Autumn Hills Sketch Plan

Letter of Intent

January 2023

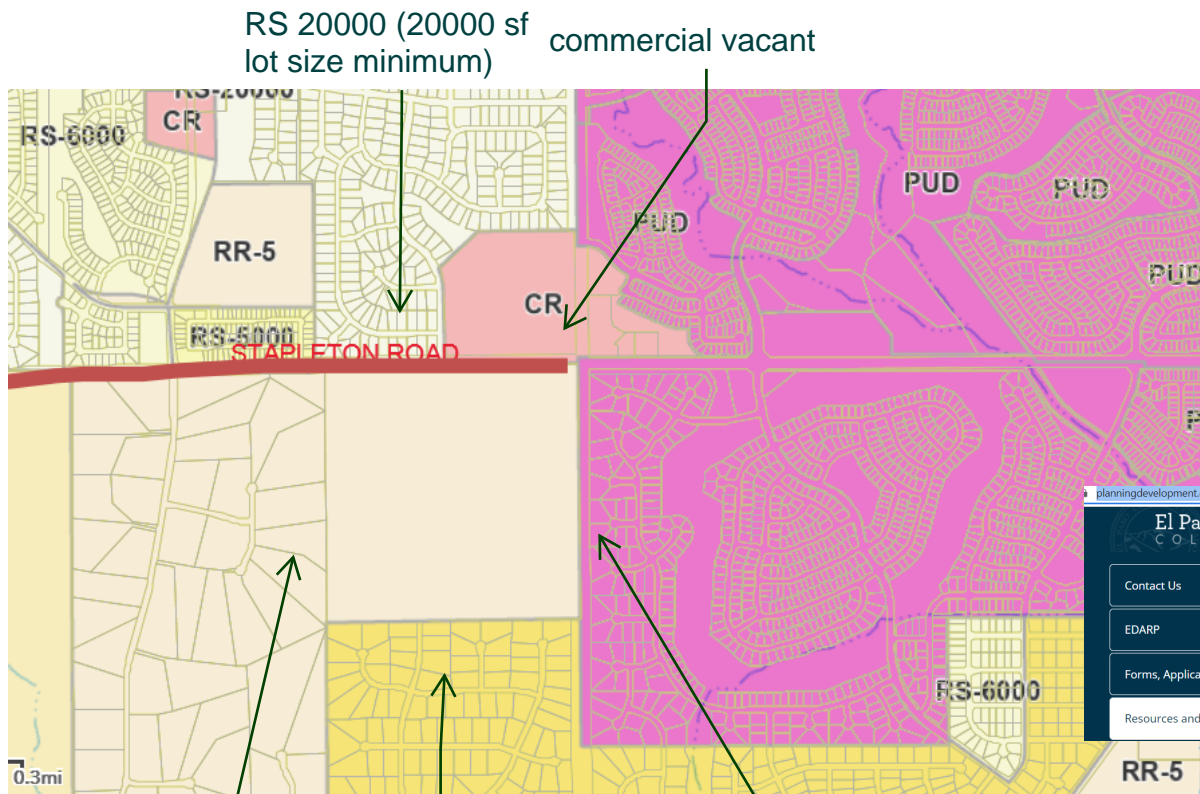
this may address the
wildlife comment
above

RS 20000 (20000 sf lot size minimum) commercial vacant

Rural 5 acre

RR-0.5 1/2 acre lot minimum

1 acre lots woodmen hills pUD

provided so one can address compatibility and transition in LOI
